# Conceptual Review Agenda

# 6805 S College Ave

## Outdoor Storage

**Description of project:** This is a request to utilize a lot with an existing single family home at 6805 S College Ave (Parcel # 96141-00-001) as outdoor storage/parking for a landscaping business. The proposed outdoor storage/parking area would be located west (behind) the existing single family home and garage. The site is located in the Low Density Mixed-Use Neighborhood (LMN) Zone District. Outdoor storage requires an addition of a permitted use, subject to Planning & Zoning Board (Type 2) review.

**3**  
1" = 20'

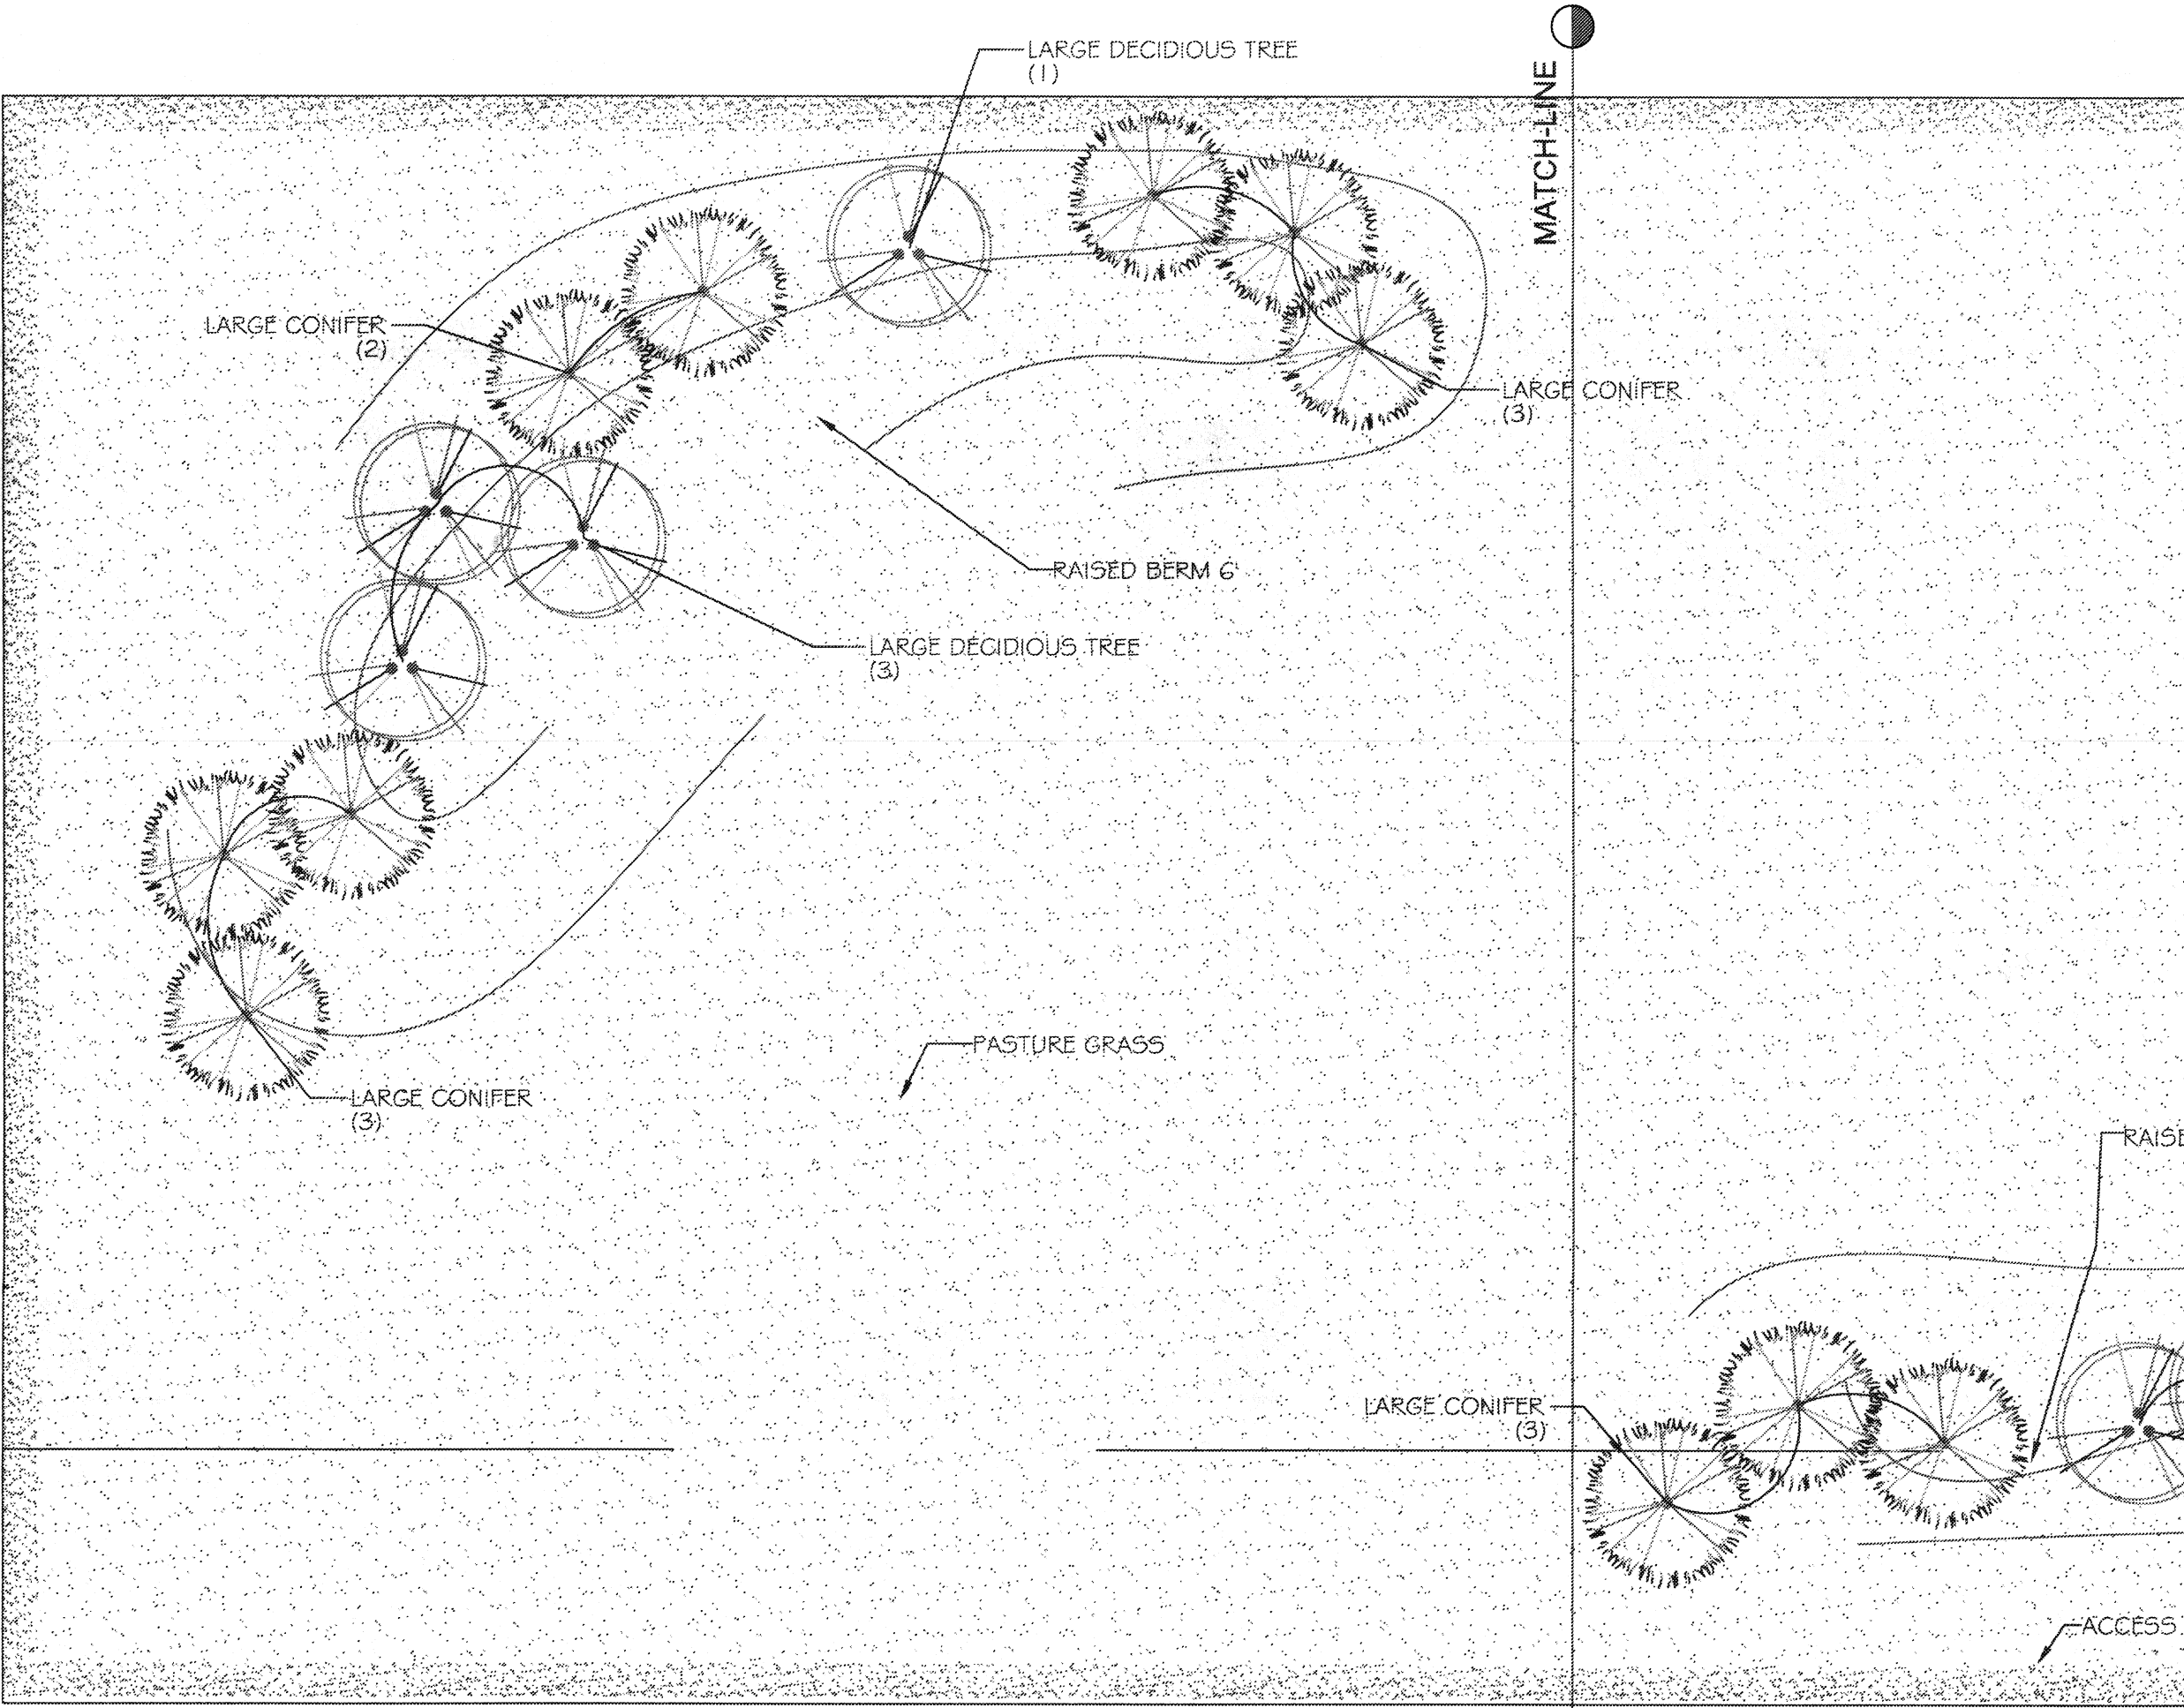
3. There have been issues related to the storage of debris from the business such as tree limbs, etc. Will that continue? and if so a solid screened containment area is suggested to keep down possible dust from the debris - please show this area and screening on the plan.

## BLUE RIDGE APARTMENTS

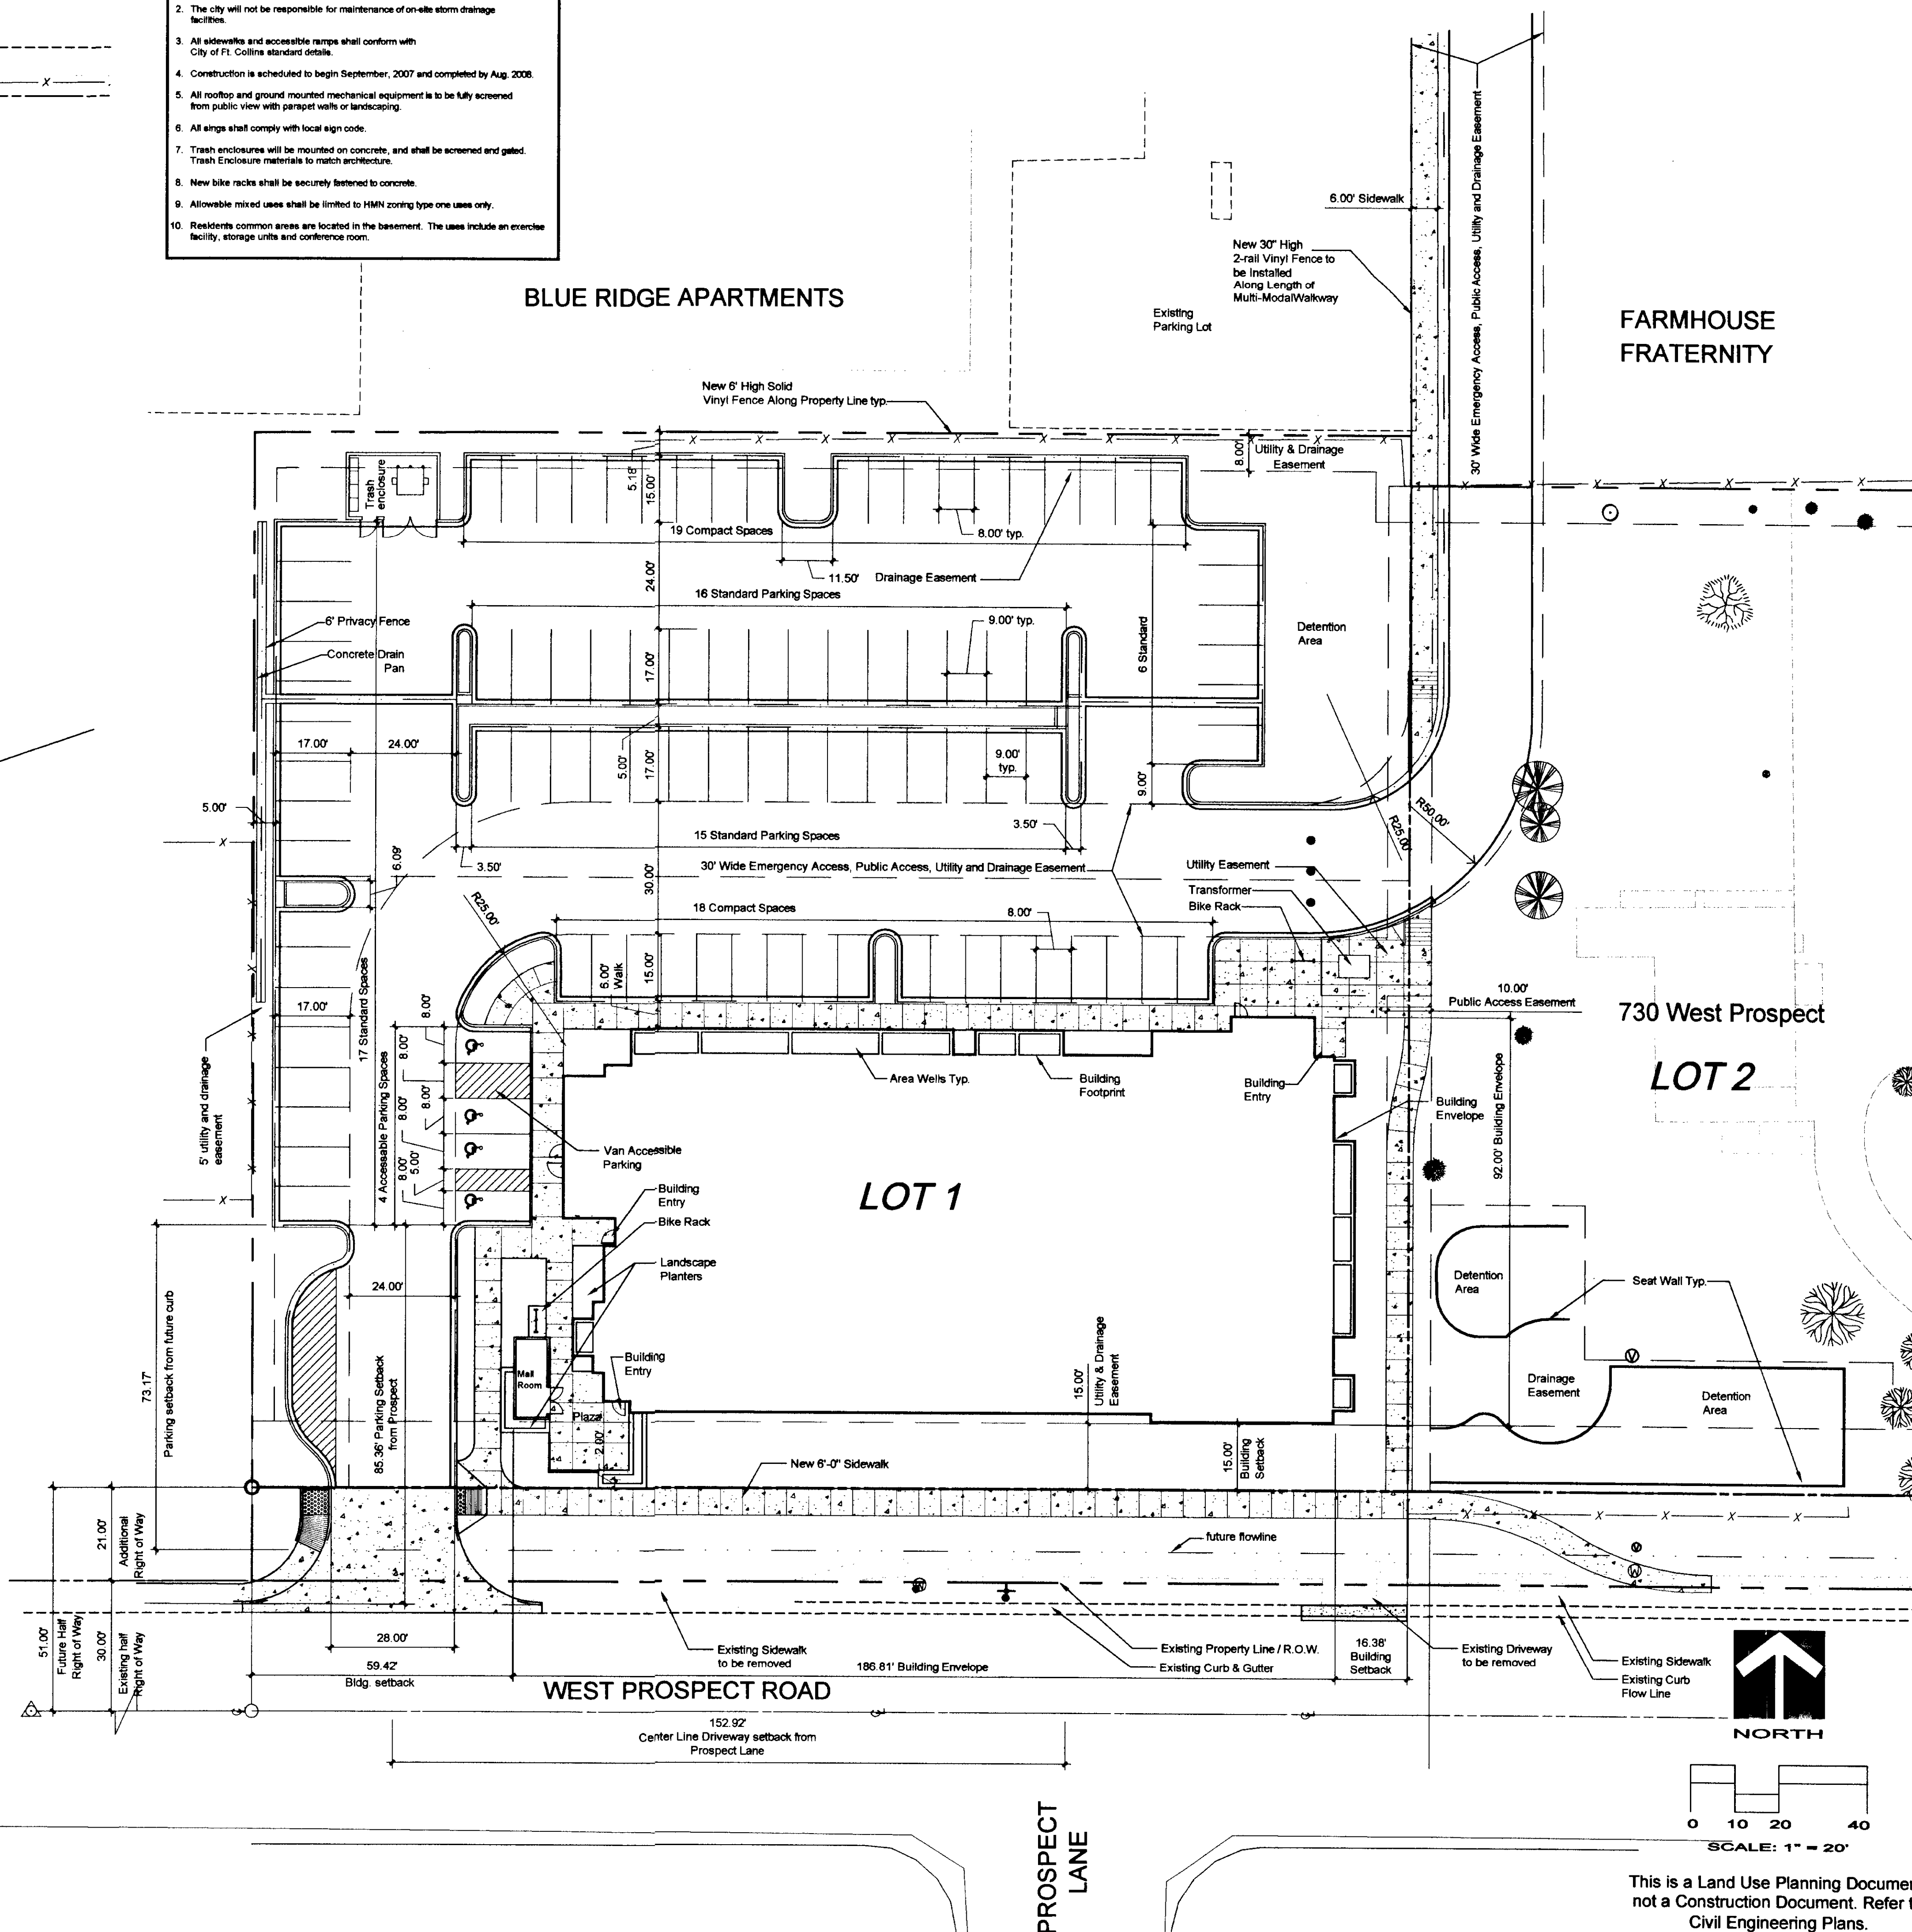
1. PEDESTRIAN CIRCULATION - The overall site plan layout results in an awkward, narrow sidewalk on the north side of the building. This sidewalk is very narrow and constrained, with car bumpers overhanging on one side, and on the other side are meter banks, electrical gear, and window wells looking into bedrooms. This looks like an inconvenient circulation facility that does not contribute to the attractiveness of the development, yet it is the primary daily route to and from CSU. This needs further discussion because any additional width would involve significant space tradeoffs.

2. Does the multi-modal walkway extend to the north toward CSU? It's not apparent on the plan. This needs further discussion because of opportunities and issues with the 30-foot easement extending to Lake Street and possible reconfiguration of the easement in conjunction with the parking lot for the apartments due north of the site.

3. BUILDING DESIGN - ENTRANCES - The building entrances are poorly defined and give an anonymous quality to the building. The safety and attractiveness of these areas need greater design attention. Also, the sidewalk connection to the south entrance is not apparent on the plan.

4. BUILDING DESIGN - FACADES - Interrelated with comments on the sidewalks and entrances, the ground floor facade on the north side has no pedestrian interest or detail features. It has what appears to be a long row of bedroom windows with no buffering layers of space, landscaping, or architecture to form a comfortable transition.
